Z-86
(2014)

PETITION NO: Z-86
HEARING DATE (PC): 12-02-14
HEARING DATE (BOC): 12-16-14
PRESENT ZONING: R-15

PROPOSED USE: Single-Family Subdivision

ZONING COMMENTS:

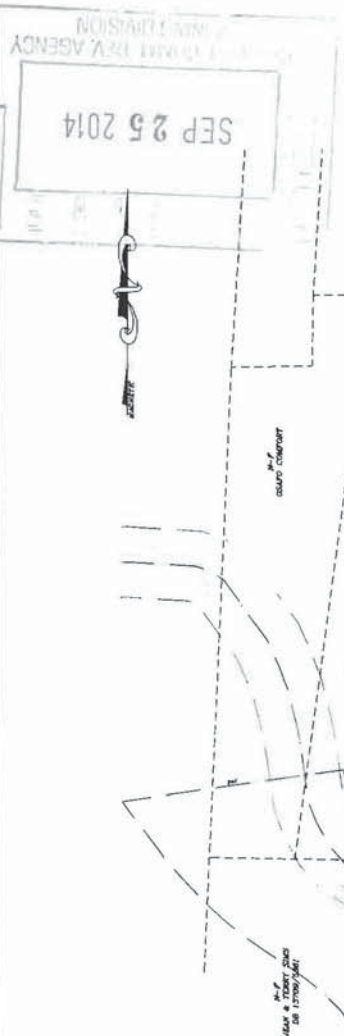
1. Reduce the front setbacks from the required 25 feet to 20 feet;
2. Reduce the minimum lot size from 7,000 square feet for lots 39, 40, and 41 to 6,250 square feet; and
3. Reduce the minimum lot width at the front setback line for lots 32, 33, 34, and 35 to 53 feet.

When projects contemplate less than 20 foot separation between units, guest parking shall be provided or the streets shall be labeled as a fire lane.

Additional Comments: Secondary water feed will be required to 6" main in Angelia Drive

Additional Comments: Sewer extension by developer required to uppermost property line (Old Alabama Rd). Sewer should be made available to church. Structures must be located so as to not encroach upon existing sewer easements and setbacks

1. This entire site discharges to the southwest into Pine Branch that traverses the southwest corner of the property. There is a small tributary to Pine Branch that crosses the southeast corner of the parcel. Both of these streams have 50-foot stream buffers and an additional 25-foot impervious setback.
2. The available building footprints for Lots 15-17 appear to be severely limited by the impervious setback buffer. Lots 24 & 25 do not appear buildable. A revised lot layout is needed to address these issues.
3. A 20-foot drainage easement will likely be required along the rear of lots 31-36 to limit offsite bypass of runoff. This will need to be taken into consideration if any perimeter landscape buffers are proposed.

- A. It is Staff's opinion that the applicant's rezoning proposal may not permit a use that is suitable in view of the use and development of adjacent and nearby properties. The subject property is bordered by a church and R-20 developments that are at lower densities than what is being proposed in this application.

- B. It is Staff's opinion that the applicant's rezoning proposal may have an adverse affect on the usability of adjacent or nearby property. A previous request for 34 lots in the Conservation Subdivision zoning category was deleted to R-15 for 27 lots.

- C. It is Staff's opinion that the applicant's rezoning proposal will result in a use which would cause an excessive or burdensome use of existing streets, transportation facilities, utilities, or schools. This opinion can be supported by the departmental comments contained in this analysis.

- D. It is Staff's opinion that the applicant's rezoning proposal is in not conformity with the policy and intent of the *Cobb County Comprehensive Plan*, which delineates this property to be in the Low Density Residential (LDR) land use category, having densities ranging from 1-2.5 units per acre. Other subdivision in the area are zoned R-15 and R-20 with lower densities and include: James Crossing (zoned R-20, 1.21 units per acre); Eddy Frances Estates (zoned R-20, 1.58 units per acre); Hank Floyd Subdivision (zoned R-20, approximately 1.61 units per acre); Landers Farm (zoned R-20, approximately 1.71 units per acre); James Acres (zoned R-20, approximately 1.71 units per acre); Dunn Hill Acres (zoned R-20, approximately 1.907 units per acre); Kristy Manor (zoned R-15 and R-20, 1.93 units per acre); and Bonner's Ridge (zoned R-20, 1.97 units per acre).

- E. It is Staff's opinion that there are existing and changing conditions affecting the use and development of the property which give supporting grounds for deleting the applicant's rezoning proposal. A previous request to rezone to CS for 34 lots was eventually deleted to R-15 for 27 lots as part of (Z-187 of 2005 – minutes attached). The proposed density is over the maximum of 2.5 units per acre allowed in the LDR land use category, and is also higher than several other subdivisions in the area.

Based on the above analysis, Staff recommends DELETING to R-15 subject to the following conditions:

- Site plan to be approved by the Board of Commissioners, with the District Commissioner approving minor modifications;
- Maximum of 32 lots;
- Fire Department comments and recommendations;
- Water and Sewer Division comments and recommendations;
- Stormwater Management Division comments and recommendations; and
- Department of Transportation comments and recommendations.

Petition No. Z-18705
Meeting Date 2/21/10
Continued Site Plan referenced in letter

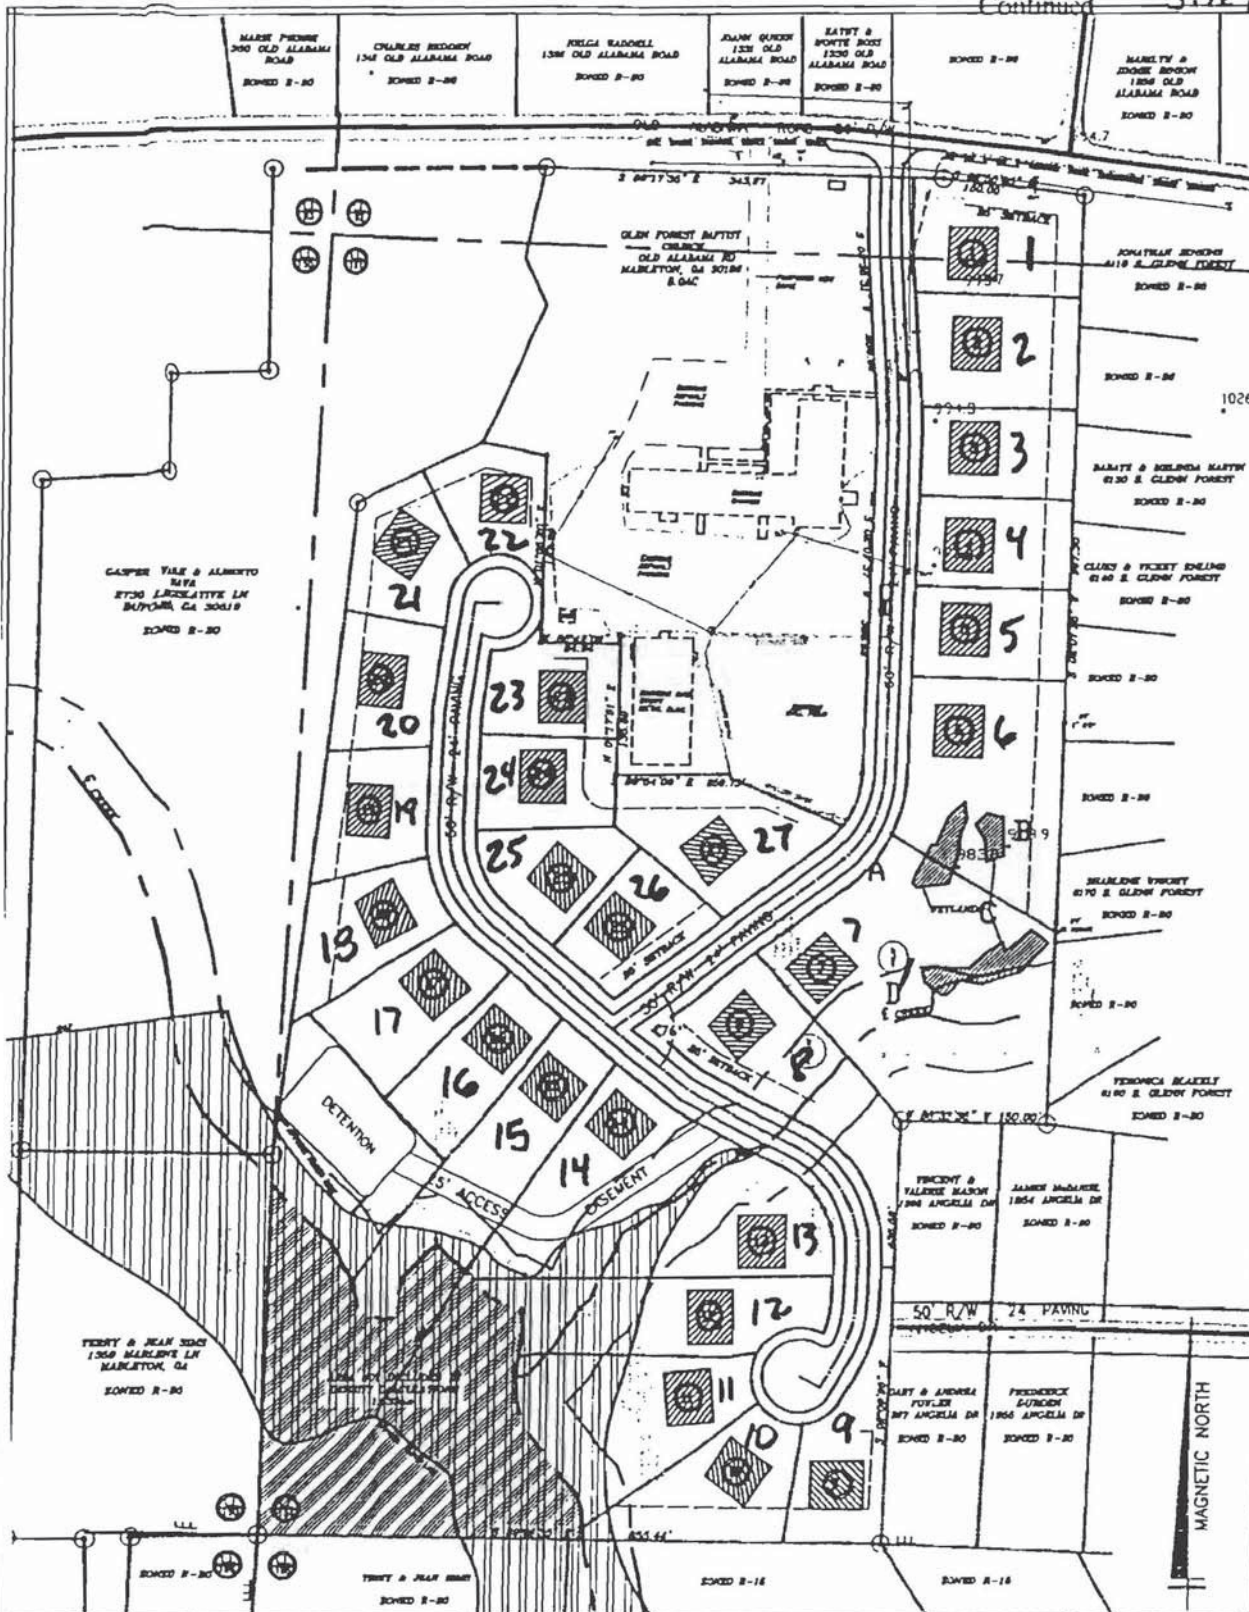
- 8) Revised Plan presented at Staff Zoning Analysis Review of 11-18-05 showing increased density from 6 lots to 8 in northeast and eliminating southwest cul-de-sac with ensuring rearrangement of lots and detention. Lot count has increased from 34 to 37. Detention / Water Quality-Best Management Practice is now without access from public road and has been moved into the Open Space area.

- 8.1) All previously made Drainage Comments remain in force.
 - 8.2) The relocation of the detention / Water Quality-Best Management Practice into an isolated area without public road access renders it unacceptable for Public / County perpetual maintenance. Recommend an operating manual be provided for County Review at Plan Review along with a funding arrangement.

- 8.3) This new plan shows the Open Space area increasing, but, at same time the detention / Water Quality-Best Management Practice located therein encumbering some of the Open Space. Suggest the Open Space calculations be refined to be compatible with plan.

- 8.4) The very small lots running against stream buffers and floodplain offer very little latitude for change in detail design. This must be considered a true conceptual plan subject to change. Therefore, Stormwater Management must reserve full right of review and comment for detail plans at Plan Review.
